Office Action Summary	Application No. 10/580,138	Applicant(s) DANERI ET AL.	
	Examiner Carl D. Price	Art Unit 3749

DETAILED ACTION

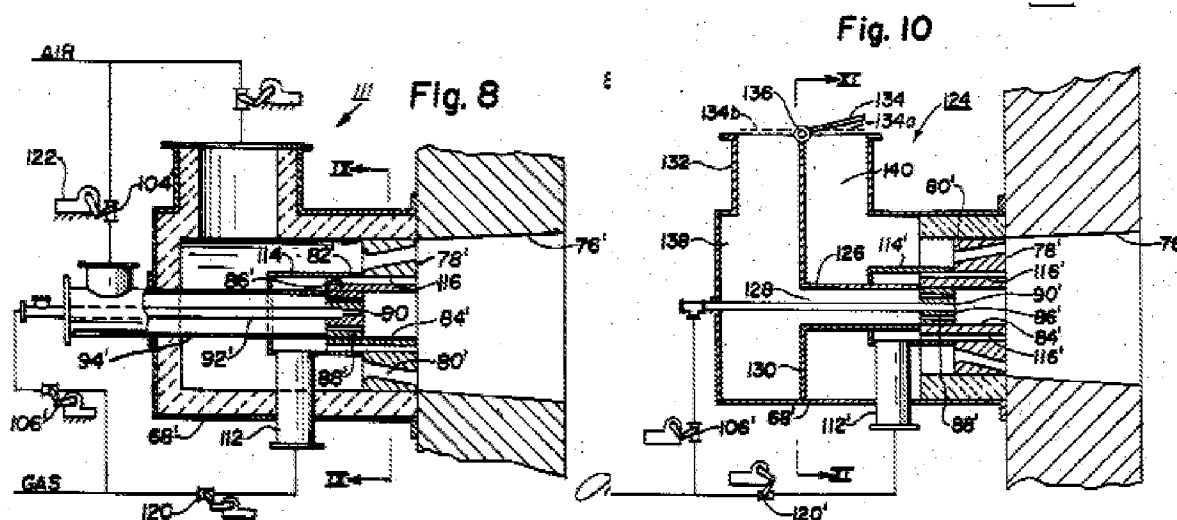
US 3418062 (Hovis et al) shows and discloses a gas burner (11 or 124; figures 8-11) comprising:

- a main metal body (68');
- an inner lance (92' or 90') for combustible gas;
- at least two outer lances (116, 116') for combustible gas;
- a single duct (not shown; e.g.- , connected to air inlet 132) for the introducing pre-heated air;
- a regulation system for the combustible gas (106', 120');
- a refractory unit (at 78', 86'),

- a series of nozzles (80') for the injection of the pre-heated air into the combustion chamber, and in that, by operating on the gas regulation system, it is possible to continuously switch from a flame functioning mode of the burner to a flameless functioning mode, the latter characterized by low emissions of polluting agents.

Fig. 9

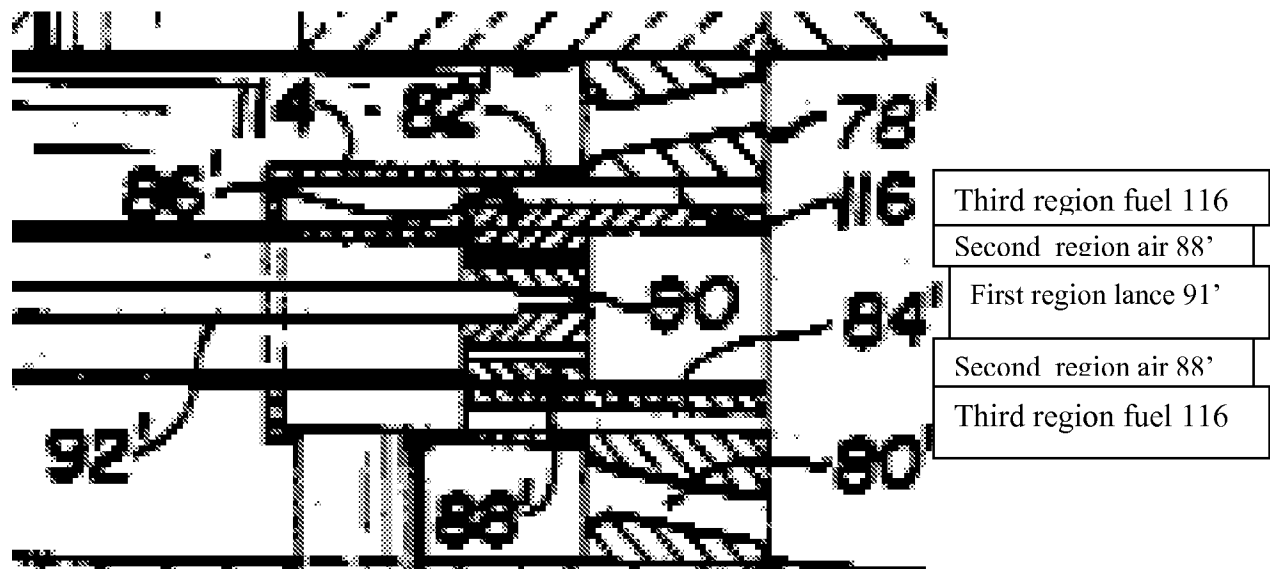
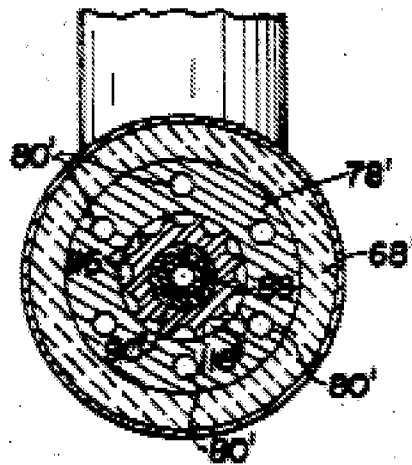
In regard to **claim 2**, **US 3418062 (Hovis et al)** shows (see the annotated figures herein below) and discloses a first region, a second region, a third region, which are concentric, said first region in turn comprising a series of calibrated holes (88’) and preferably a free annular crown (86’), the latter for allowing the passage of a sufficient quantity of air (88’) suitable for preventing the overheating of the inner lance (92, 90; 90’).

In regard to **claim 3**, **US 3418062 (Hovis et al)** shows (see the annotated figures herein below) nozzles (88, 88’) for the air is housed in the second region.

In regard to **claims 7, 8 and 10**, **US 3418062 (Hovis et al)** shows the nozzles of said series of nozzles situated at an equal distance along a coaxial circumference with the inner lance (90’, 92’) and lying on a base surface of the second region (see the annotated figures herein below).

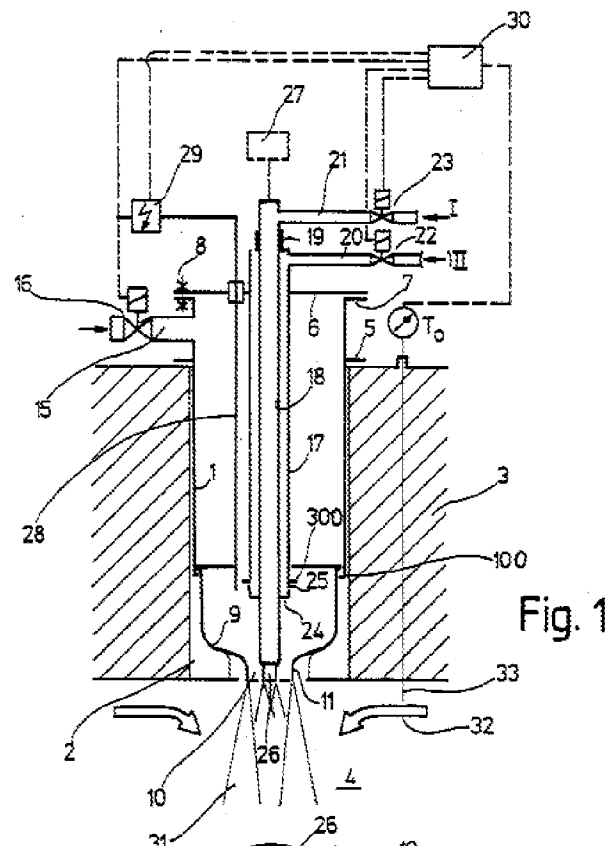
US 5570679 (Wunning) teaches, from applicant's same multi-mode flame and flameless burner field of endeavor, teaches, from applicant's same multi-mode flame and flameless burner field of endeavor, means introducing pre-heated air (15) and wherein when operating on the gas regulation system (22, 23, 30), it is possible to continuously switch from a flame functioning mode of the burner to a flameless functioning mode (i. e. - "an essentially flame-- and pulsation-free reaction"), the latter characterized by low emissions of polluting agents.

(4) A **lateral air supply stub 15** is connected to the jacket tube 1 outside the furnace wall 3; a combustion air valve 16 is located in this stub 15, and **optionally preheated combustion air** can be supplied by way of the stub 15. The combustion air supply stub 15, together with the jacket tube 1 and the combustion air valve 16, forms the air supply device, which as seen from the drawing is shaped such that all the combustion air supplied acts upon the combustion chamber 9 and emerges from the outlet opening 10 thereof. (Highlighting and Underlining Added)

(15) As soon as the **furnace chamber 4 has been heated to the ignition temperature of the fuel** assigned to the outer fuel lance 17, which is ascertained by a temperature sensor 33 protruding into the furnace chamber 4, **the control unit 30 switches the burner over to a second operating state**; to do so, it closes the first fuel valve 22 and opens the second fuel valve 23. **This switchover may be done in stages or continuously.** (Highlighting and Underlining Added)

Ausgegeben
2 Blatt - Bl. 2

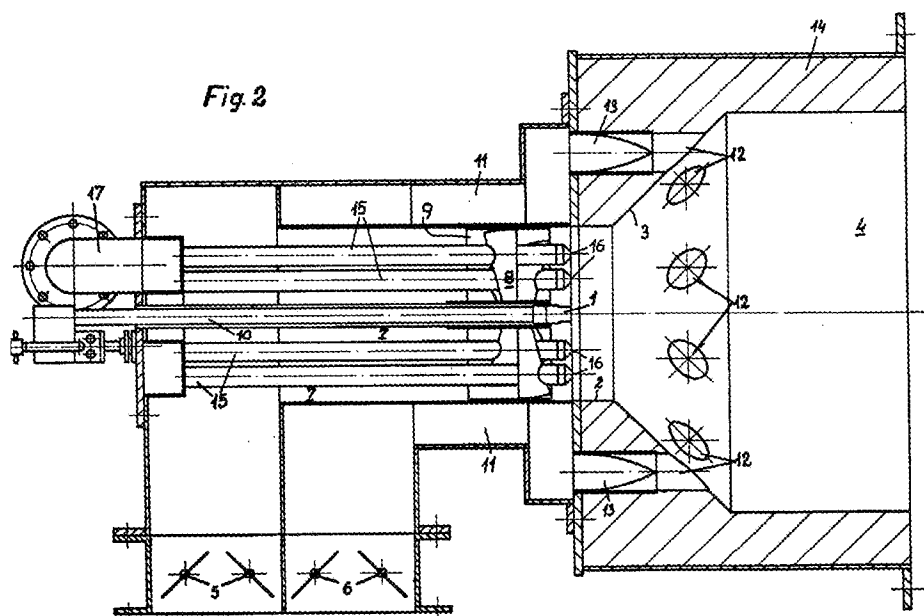
AT 358702 teaches, from applicant's same burner field of endeavor, a burner including at least two pass-through holes (12) for housing at least two outer side lances (13) as a means for communicating and directing a fluid to the combustion chamber.

Nummer:
Int. Cl. 8:
Offenlegungsgeweg:
DE 197 62 336 A1
F 23 D 14/22
27. Mai 1999

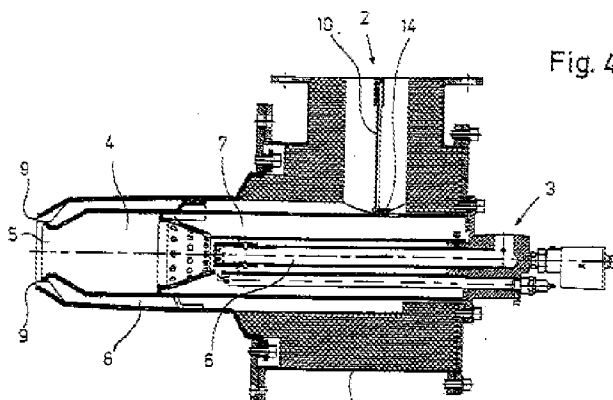
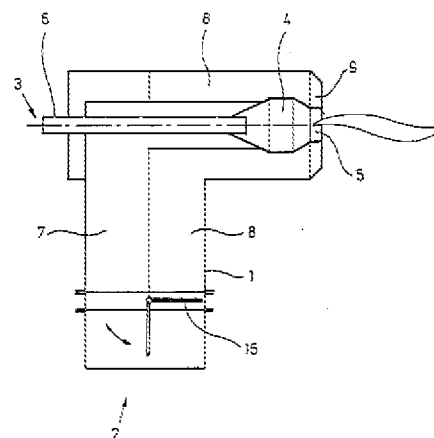
See **DE 19752335 A1** which discloses air-inlet (2) for pre-heatable combustion air:
